DEVELOPMENT ASSESSMENT CASE NUMBER: CD-2014-0010

Presentation of a Development Assessment Report for Austin Oaks Planned Unit Development (PUD), located at the southwest corner of Spicewood Springs Road and Mopac Expressway, within the Shoal Creek Watershed.

AUSTIN OAKS PLANNED UNIT DEVELOPMENT
Development Assessment Staff Review Comments

LAND USE PLAN

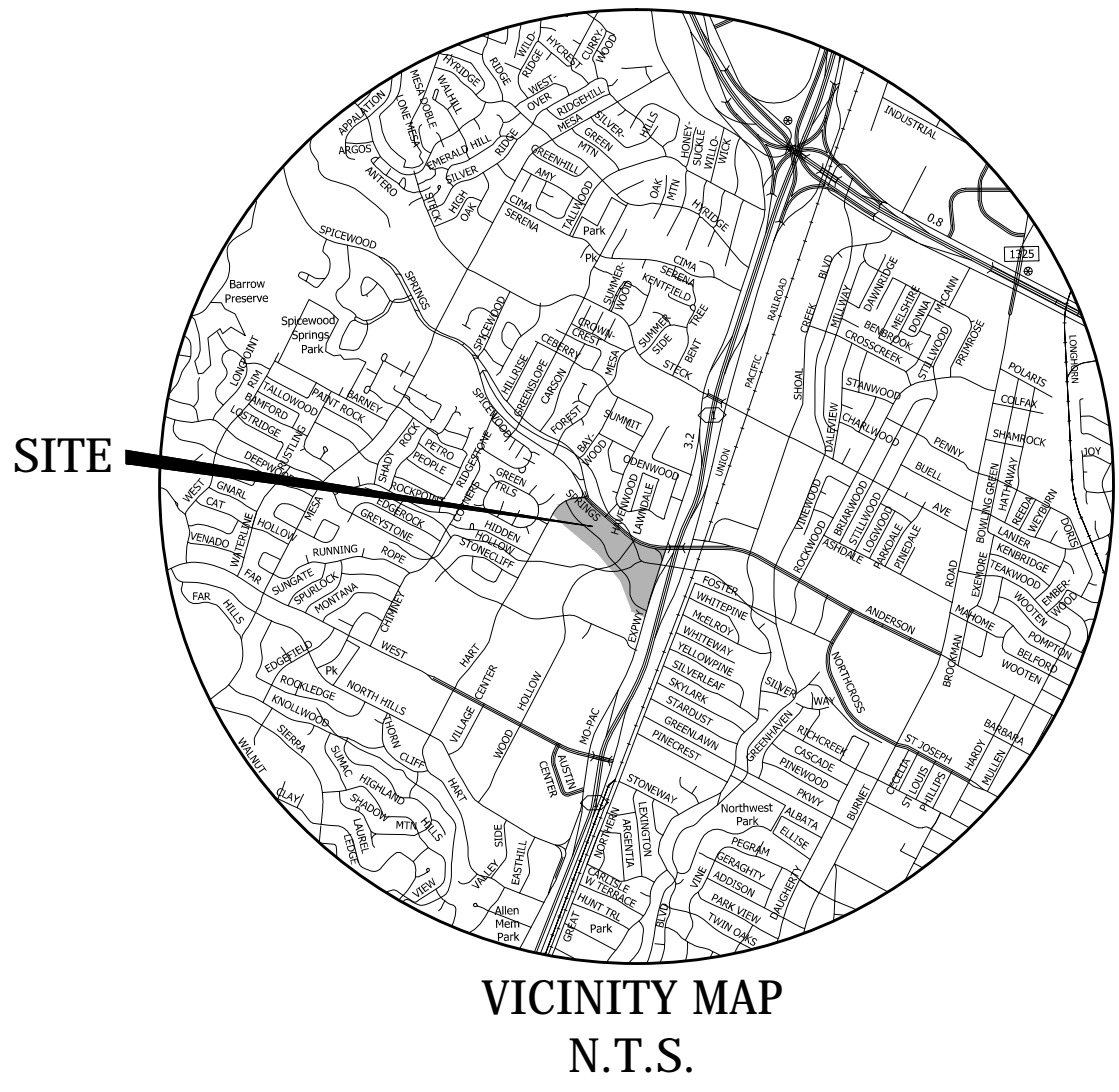
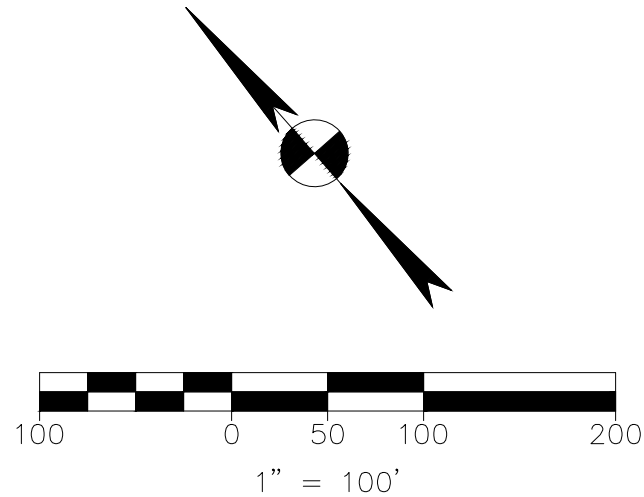
1. Portions of Area C & F are located with the 100-year floodplain.
2. If a construction element application is sought, applicant will be required to comply with current floodplain regulations including restrictions of constructing buildings or parking within the limits of the 100-year floodplain, containing the floodplain within an easement and all other floodplain regulations found within the Land Development Code.
3. Changes to the existing parking lot in Area C located within in the floodplain cannot increase the existing non conformity of the existing development. For example, a restriping of the existing lot which increases the number of existing parking spaces in the floodplain would not be allowed.

The summary letter PUD Requirement chart (page 2 of the letter) should be changed to remove the reference to Alternative Equivalent Compliance for sidewalks. Also remove the reference to Alternative Equivalent Compliance for sidewalks on the Land Use Plan. The Tier 1 & 2 Compliance Chart clearly states that Core Transit Corridor sidewalks will be provided as required – place that note on the Land Use Plan.

4. Tier Two requirements: Where is the 25% open space located? Either each site plan must provide 25% independently, or the PUD land use plan must show the location of the open space.
5. Art – Provide documentation from the Art in Public Places office concerning this requirement. There is currently no method in which to enforce this requirement, and the AIPP office has requested additional input prior to a PUD choosing this option from Tier Two requirements.
6. Community Amenities – Show the location of the proposed community meeting space on the PUD land use plan.
7. It is not clear why the 1st floor cannot contain pedestrian oriented uses.
8. Clarify the exact amount and percentage of affordable housing proposed for this PUD.

9. Will driveways/curb cuts remain or be relocated?
10. Please provide all required information on the land use plan (e.g., existing land uses/zoning).
11. Please identify open space(s) on land use plan.
